MIL-D-70789A (AR)  
AMENDMENT 2  
09 November 1994  
SUPERSEDING  
AMENDMENT 1  
14 April 1993

### DYNAMIC REFERENCE UNIT (DRU)

This amendment forms a part of MIL-D-70789A (AR), dated 15 June 1992, and is approved for use by the US Army Armament, Munitions, and Chemical Command, and is available for use by all Departments and Agencies of the Department of Defense.

Figure 11  
ESS Temperature Cycle

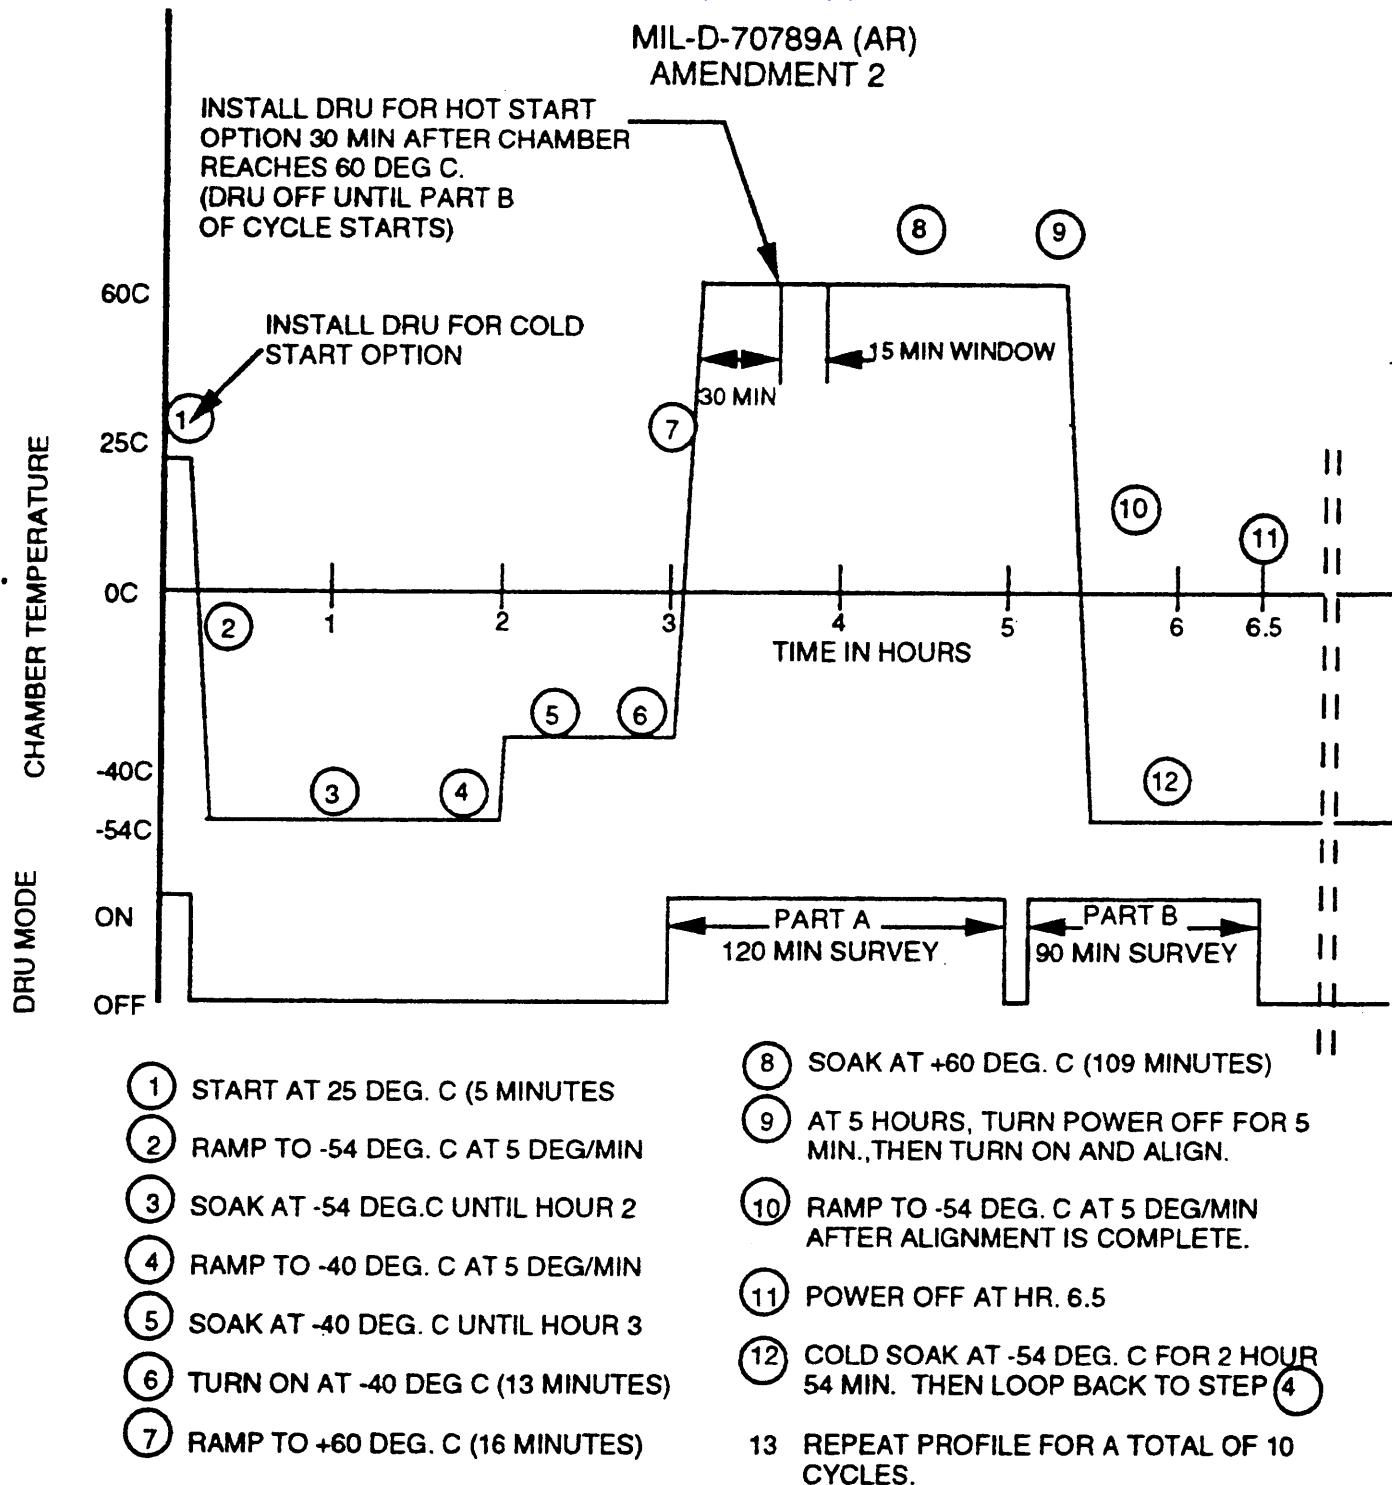
Figure 11, Temperature Cycling: Delete in its entirety and substitute as included page 67.

NOTES: 1. TIMES ARE APPROXIMATE AND ANY ONE FUNCTION MAY DEVIATE BY UP TO 5 PER CENT. THE OVERALL CYCLE (AFTER THE FIRST CYCLE) SHALL BE 6 HOURS 30 MINUTES - 5, +15 PERCENT.

2. PROVISIONS ARE MADE TO START THE TEST AT ROOM TEMPERATURE OR AT HIGH TEMPERATURE IN ORDER TO FACILITATE PRODUCTION TEST WITH MULTIPLE DRUS IN THE SAME CHAMBER. THE OVERALL ESS TEST TIME IS THE SAME FOR A HOT OR COLD START.

3. CHAMBER RAMP RATES ARE SPECIFIED AS MINIMUM RATES.
